December 21, 2017

ND-17-1726
10 CFR 50.90
10 CFR 52.7

Southern Nuclear Operating Company
Vogtle Electric Generating Plant Units 3 and 4
Request for License Amendment and Exemption:
Changes to Tier 2* Departure Evaluation Process (LAR-17-037)

Proposed Tier 2* Departure Evaluation Process

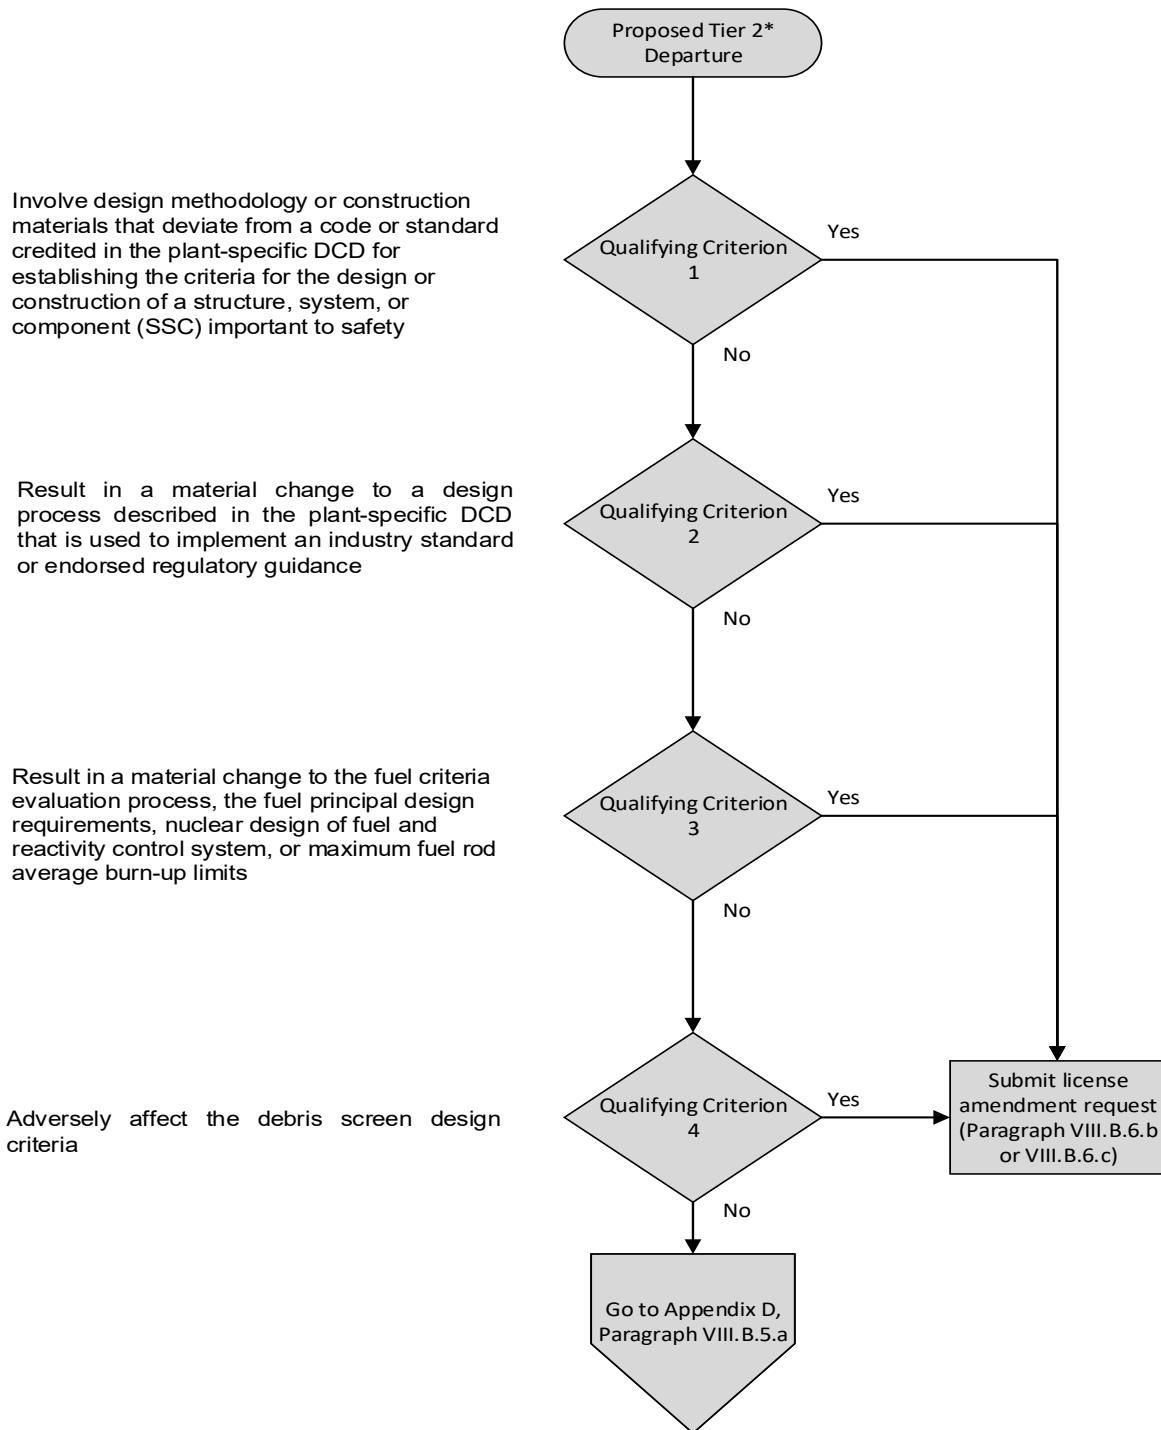
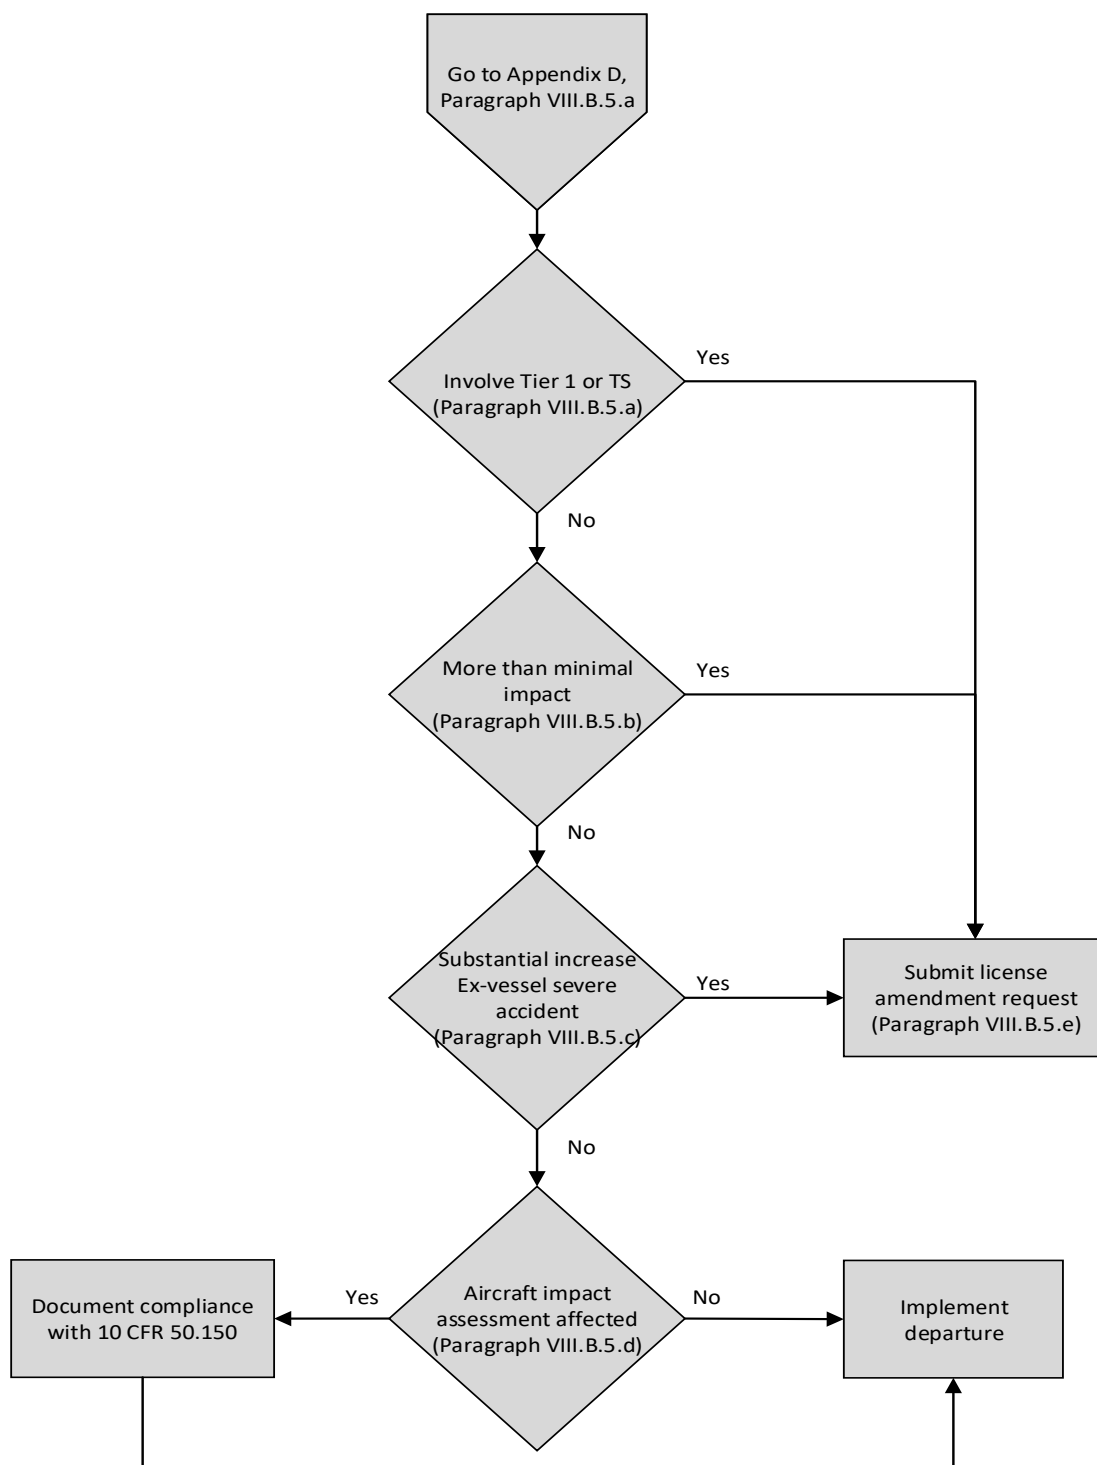
Enclosure 4 provides a reviewer's aid which depicts the proposed Tier 2* departure evaluation process.

If the screening criteria are all answered no, the proposed change would be considered a "Qualifying Change" and would be processed in accordance with the Tier 2 departure evaluation process specified in 10 CFR Part 52, Appendix D, Paragraphs VIII.B.5.a through VIII.B.5.e (See Enclosure 4 for a proposed process diagram).
